DCA Runway 19 RNAV Approach Redesign

Presented to: DCA Noise Mitigation CWG

By: Matthew Fisher, FAA

Date: October 27, 2022

IAFs: Current vs ABCx2 vs FAA New

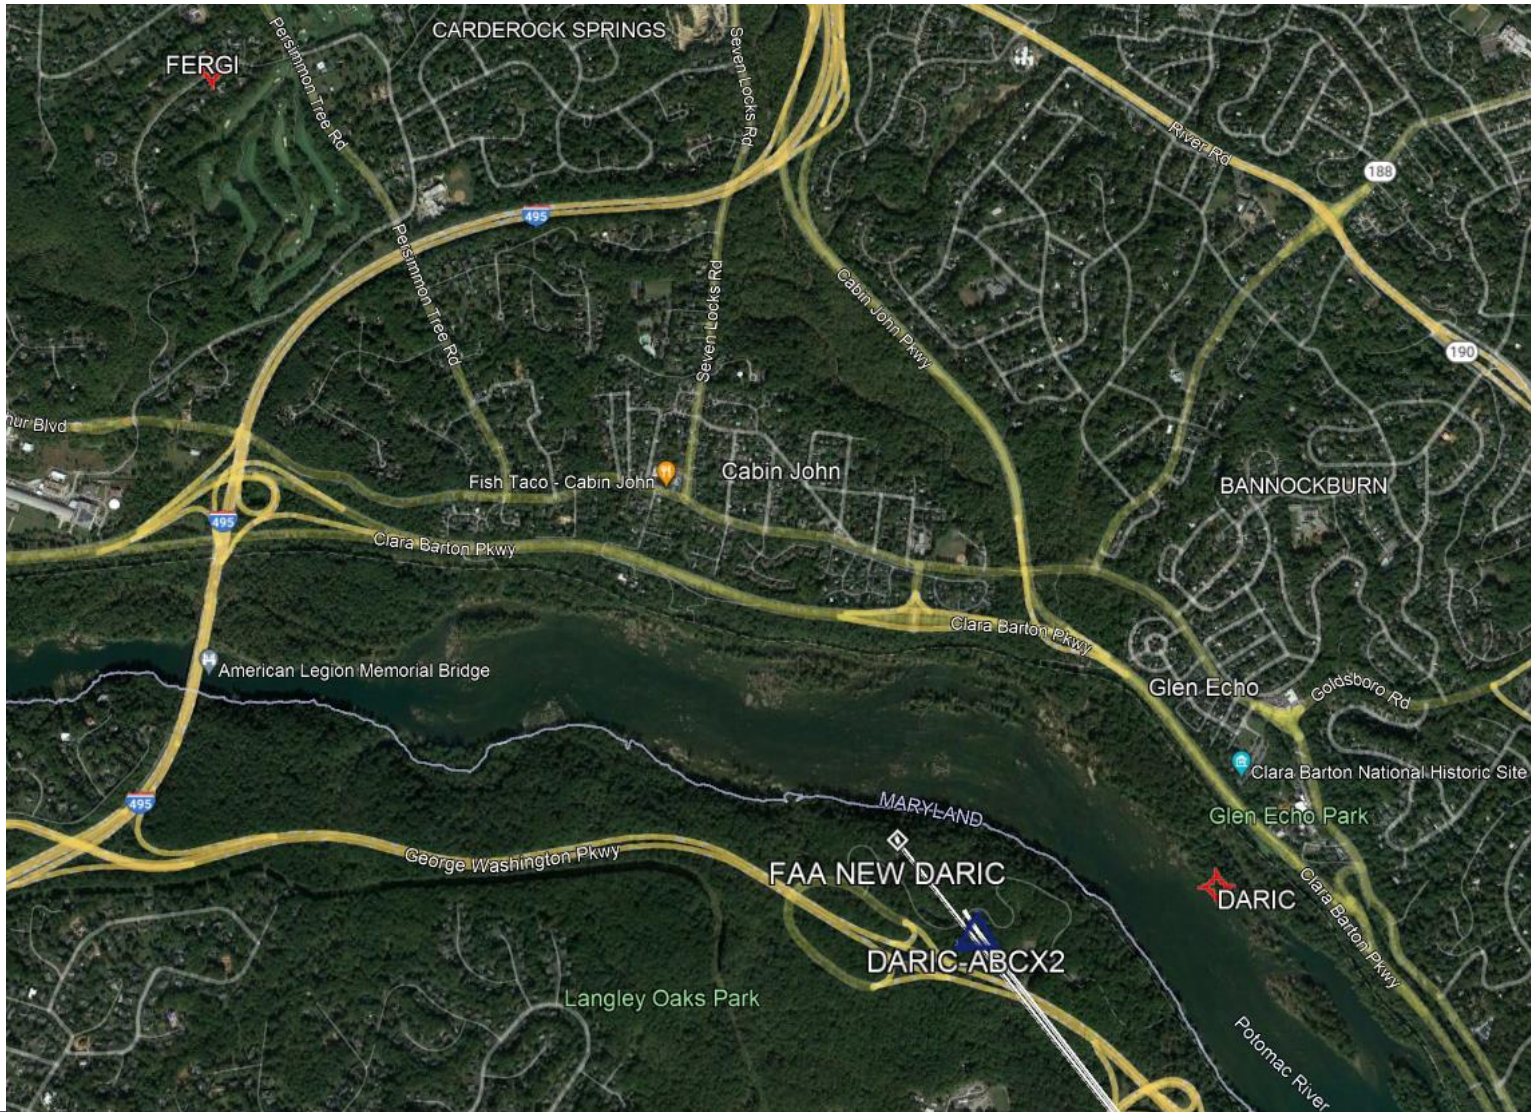
FAA NEW DARIC is 1400 feet Northwest of the proposed ABCx2 DARIC

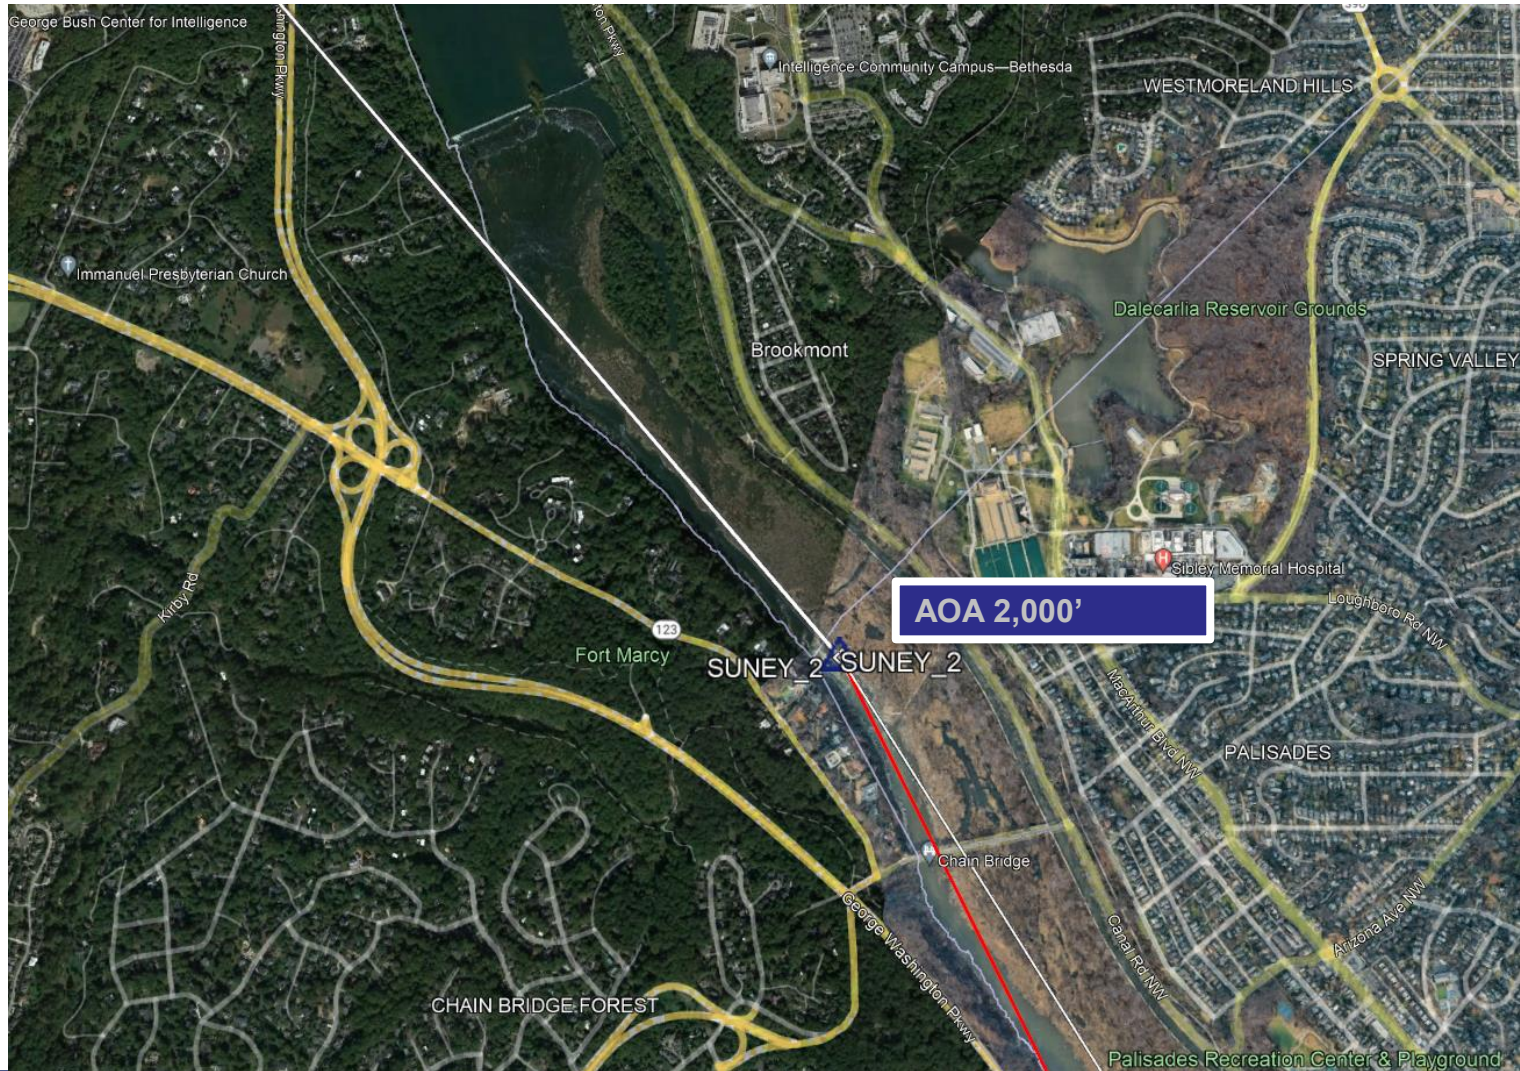
GPS and RNP Both cross SUNEY at or above 2,000'

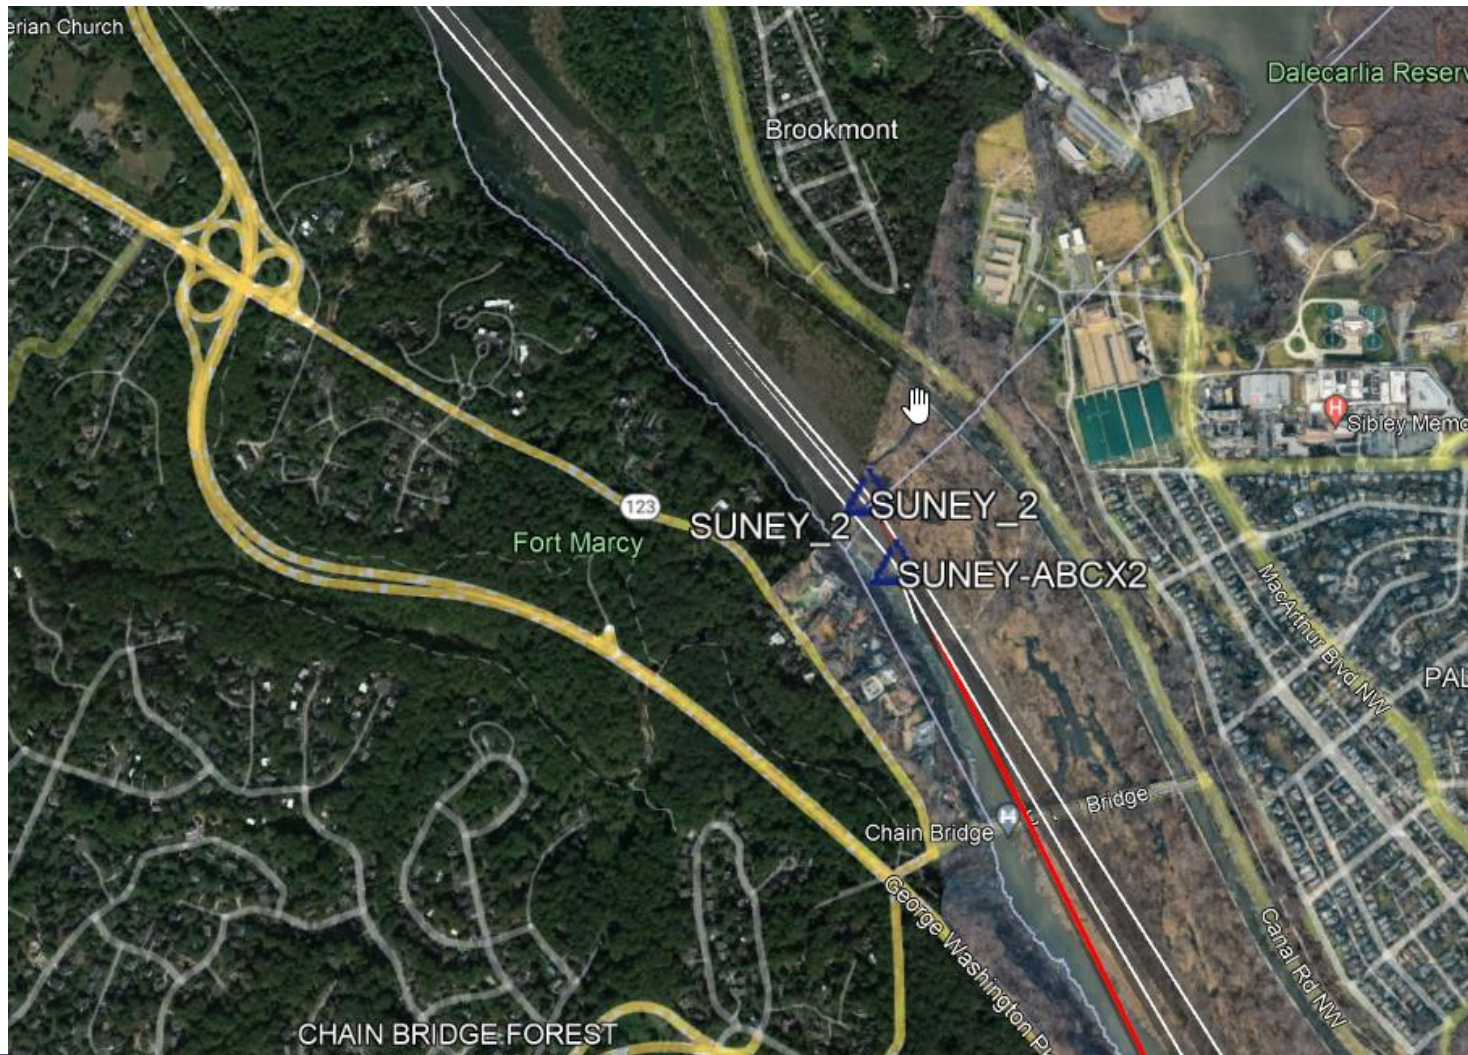
300 Foot difference between SUNEY_2 AND SUNEY-ABCx2

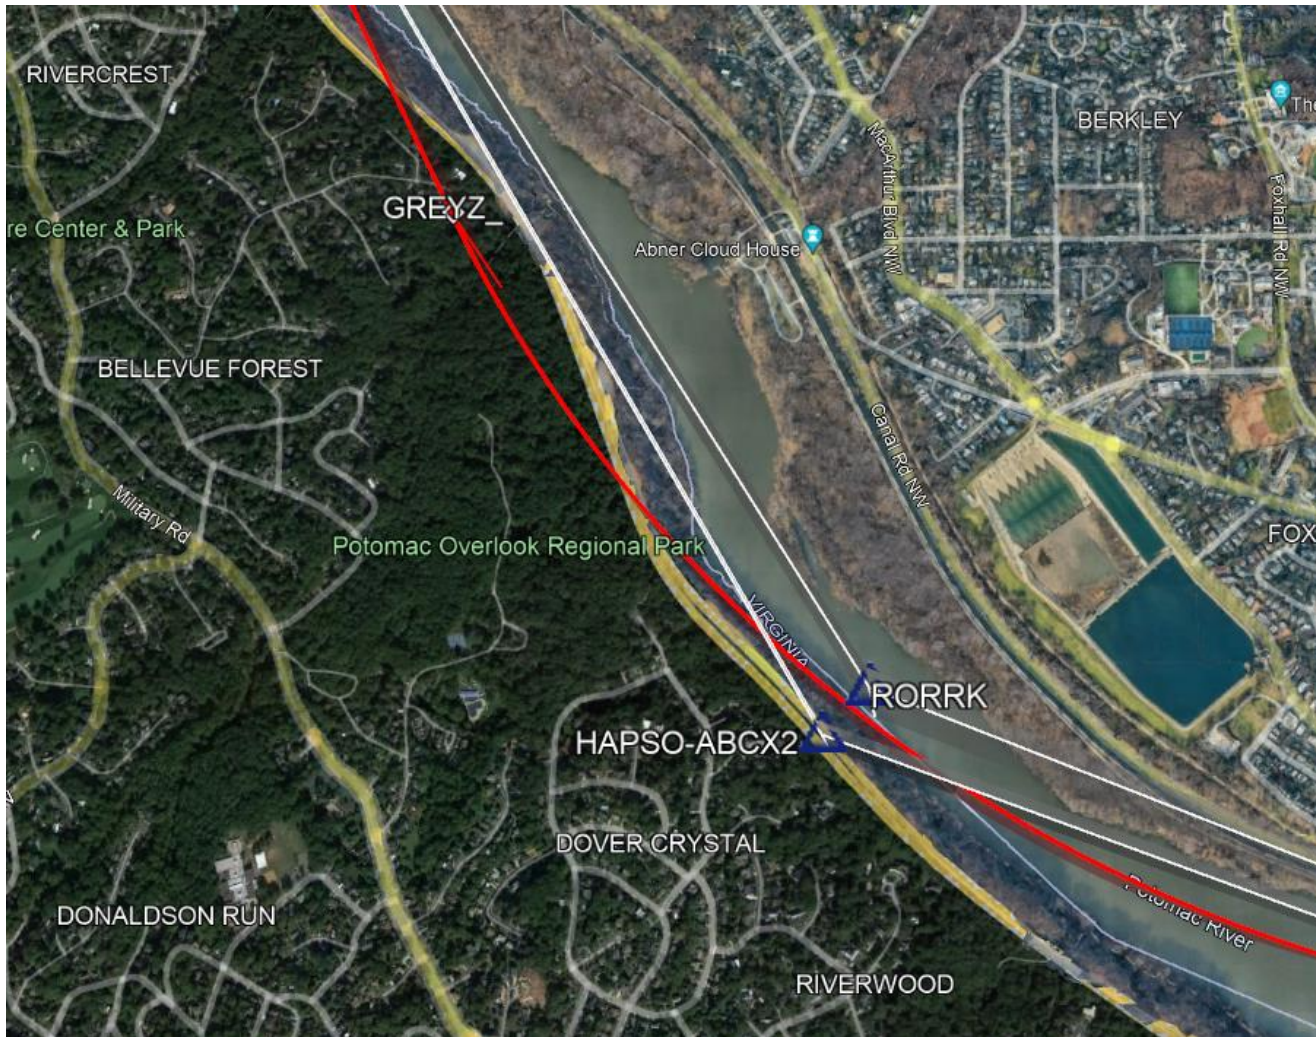
Approximately 400 foot difference between HAPSO-ABCx2 and RORRK. RNP track shown in Red.

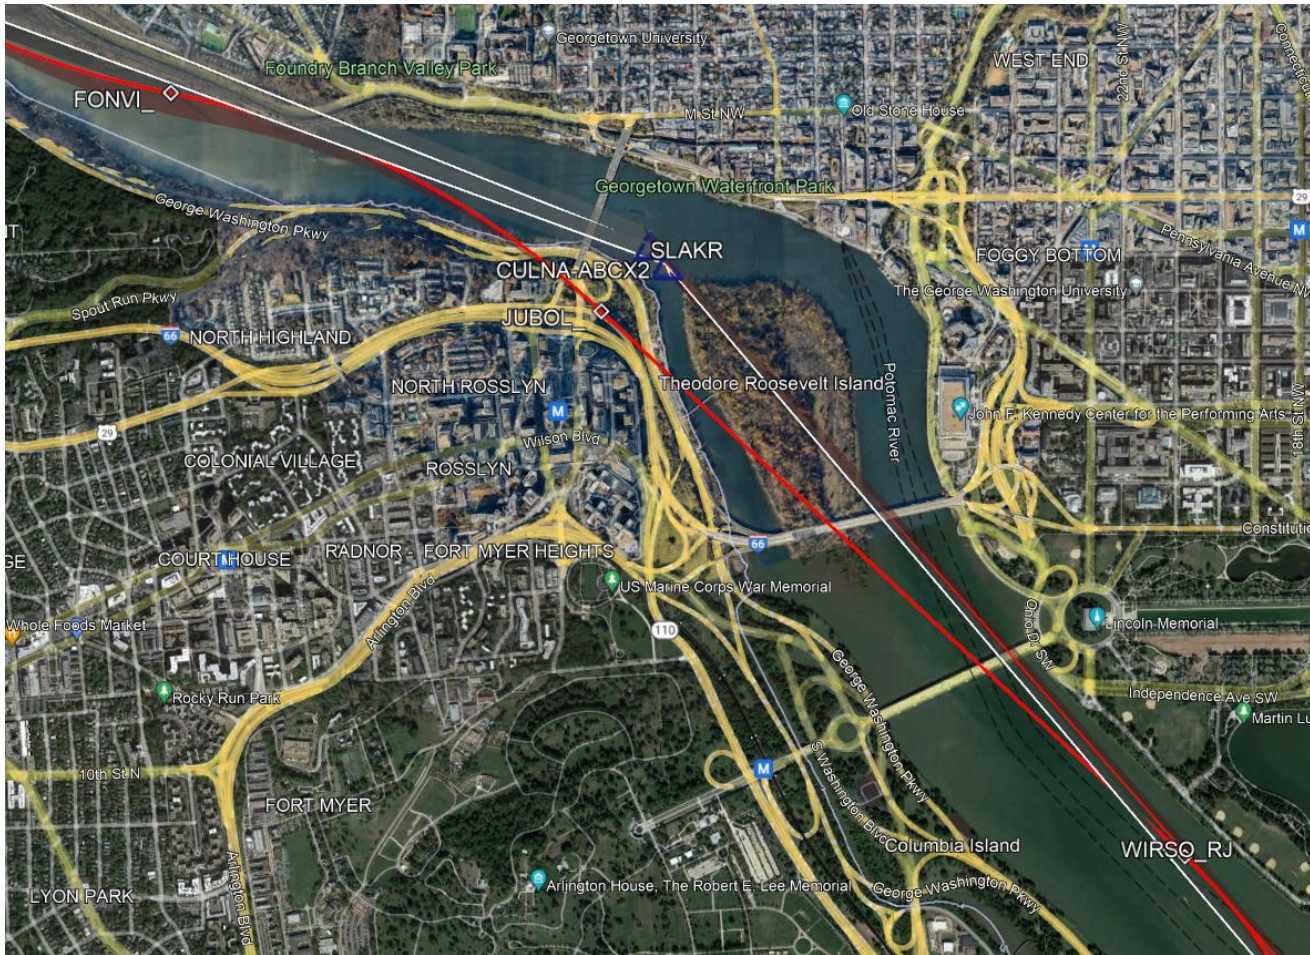
SLAKR is 270 feet NW of CULNA-ABCX2

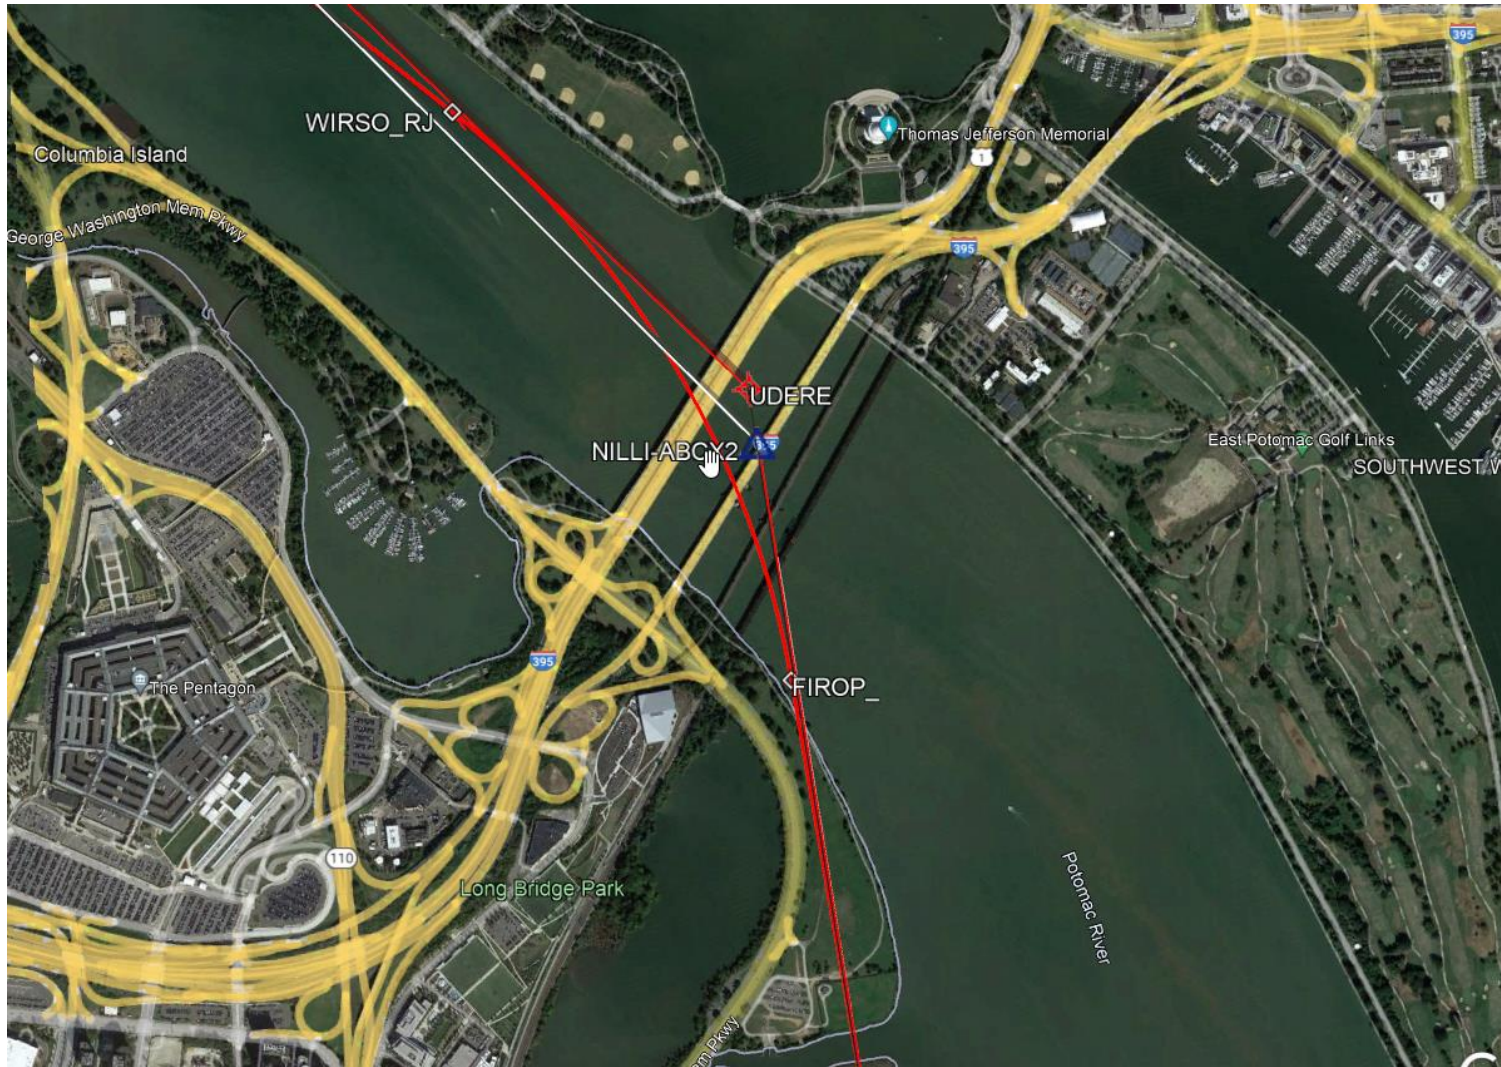
UDERE is 393 Feet north of NILLI-ABCX2

River Visual RWY 19

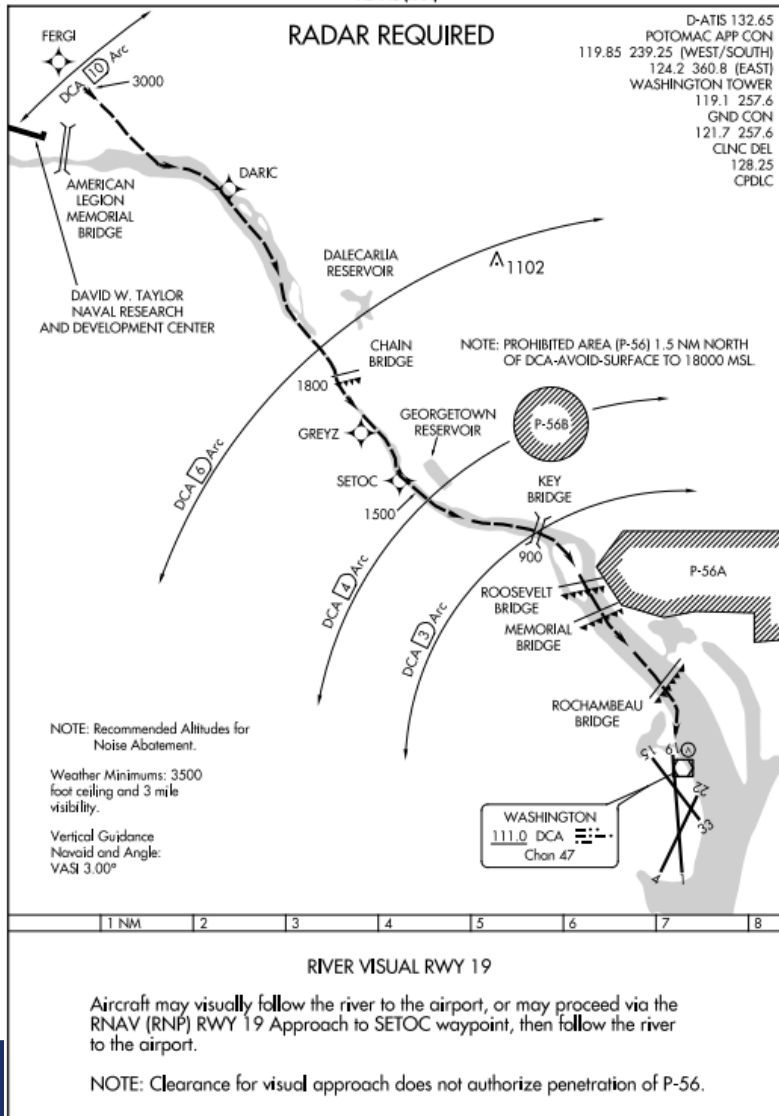
- Graphics will be updated to reflect GPS Y RWY 19 Approach path
- Updated Chart Note: Aircraft may visually follow the river to the airport, or may proceed via the RNAV (RNP) RWY 19 or RNAV (GPS) RWY 19 to SETOC or RORRK waypoints, then follow the river to the airport.
